PIC18FXX2

PIC18FXX2 Rev. B5 Silicon/Data Sheet Errata

The PIC18FXX2 Rev. B5 parts you have received conform functionally to the Device Data Sheet (DS39564**B**), except for the anomalies described below.

FIGURE 1: PINOUT DIAGRAM FOR PIC18F442/452, 44-PIN QFN PACKAGE

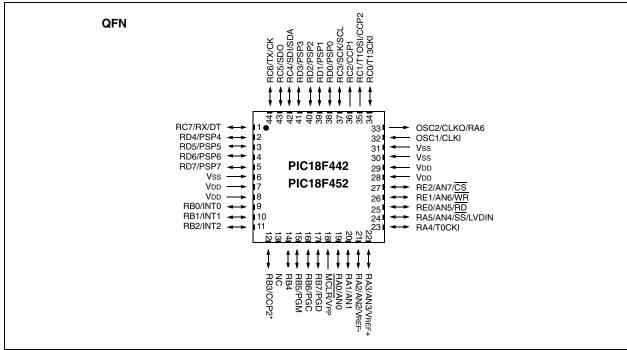
- 1. The "**Pin Diagrams**" on pages 2-3 of the Data Sheet are amended with the addition of the 44-pin QFN pinout, shown in Figure 1.
- 2. Table 1-3 of **Section 1.0** "**Overview**" is replaced with an updated version which adds a column for QFN pin assignments. A row is also added for previously unlisted NC pins. All new information is indicated in **bold**.

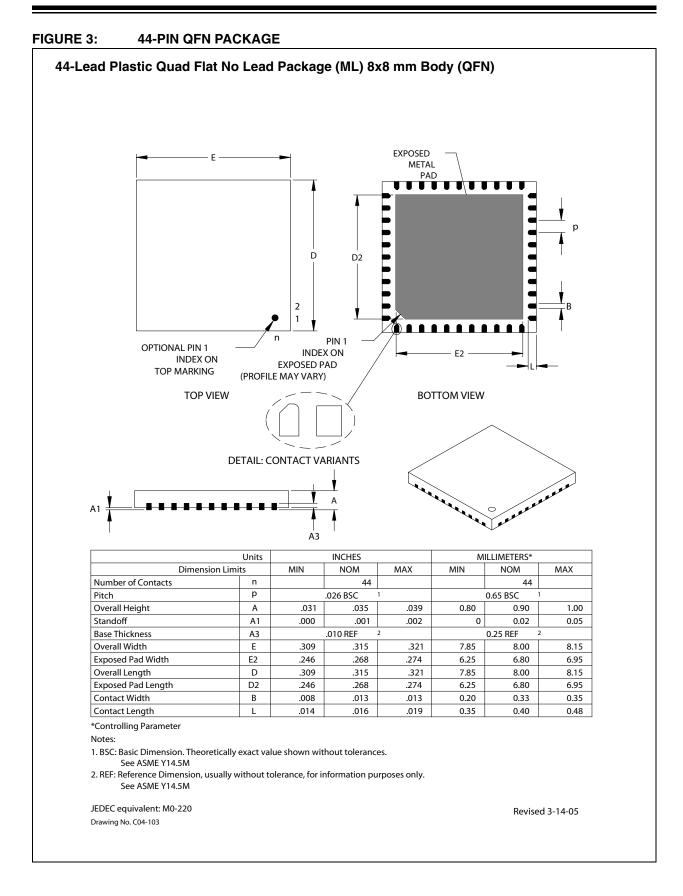
- Section 24.1 "Package Marking Information" is amended to include a marking template and example for 44-pin QFN devices. These are shown in Figure 2.
- 4. Section 24.2 "Package Details" is amended to include the mechanical drawing of the 44-pin QFN package following the existing drawings, shown in Figure 3.
- 5. In the "PIC18F442/452 Product Identification System" (page 329), the "Package" options are amended to include the new line item:
